Copper Bond Wire FAQ

Technical FAQ:

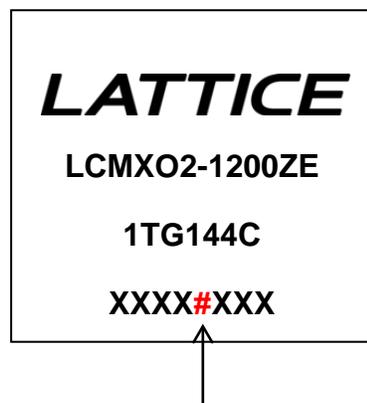
Devices with Cu-wire material sets can be identified by a numeric value in the fifth position of the datecode marked on the topside of the devices. An alpha character in the fifth position indicates a gold bond wire (Au-wire) material set. This datecode is also marked on the label on the outside of the inventory box as well as on the anti-static, moisture barrier bag within. See device topside marking example below.

Numeric Character in fifth position of Datecode indicates Cu-wire material set
Alpha Character in fifth position of Datecode indicates Au-wire material set
